VALIDATION REPORT

**Switching of fuel from coal to palm
oil mill biomass waste residues at
Industrial de Oleaginosas
Americanas S.A (INOLASA)**

Date of Issue	Project Number
9 th July 2007	CDM.Val.0592
Project title	Organisational unit:
Switching of fuel from coal to palm oil mill biomass waste residues at Industrial de Oleaginosas Americanas S.A	SGS Climate Change Programme
Revision number	Client:
00	Industrial de Oleaginosas Americanas S.A

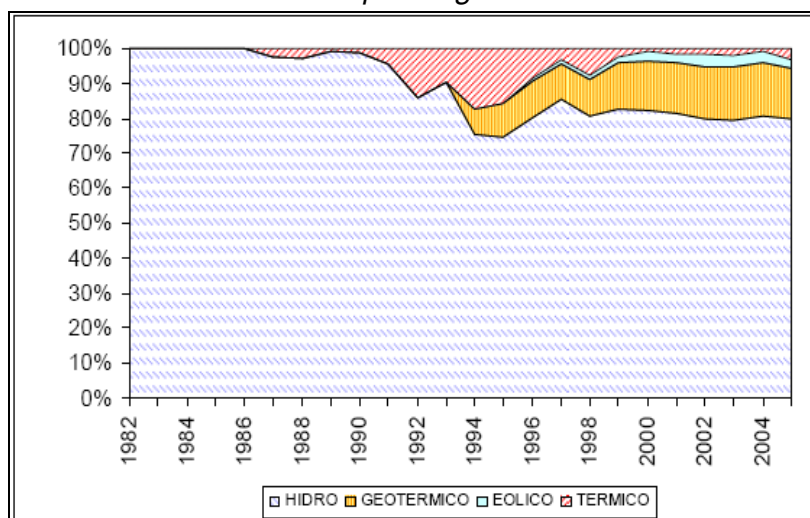
No.	Type	Issue	Ref
2	NIR	The grid emission factor of 488.35 tCO ₂ /GWh is used for the Costa Rican grid. This factor has been taken from the registered small-scale CDM project “Cote small-scale hydro power project” (0251)	2.4

In project 0251, the baseline has been established as of 2004 (start of crediting period). Please confirm if there were any changes in the grid composition since then and corresponding grid emission factors during 2004-06.	
--	--	---	--

You indicate that some new capacity has been added to the grid based on imported fossil fuels. However based on more recent PDDs, you estimate the real grid emission factor to be significantly lower than the original value applied. Please clarify the reason for this lower value if the recent additions to the grid are fossil fuel based (or is this only caused by the calculation method)

The Costa Rican grid is represented mainly by hydro power generation. There are no proved fossil fuel storages in the country; still some new capacity has been added to the grid based on imported fossil fuels.

The following image represents the historical distribution of power generation sources. It can be seen that for the 1982-2003 period, the use of thermal power plants has reached a 4.4 %.

The new capacity based on fossil fuels has been added since the late nineties, influencing a traditionally hydro-based grid. From that time up till 2004 there has not been a relevant change in the grid as it can be seen from the figure above.

Revised emission factor of 628.6tCO₂e/GWh including details have been provided. NIR2 closed.
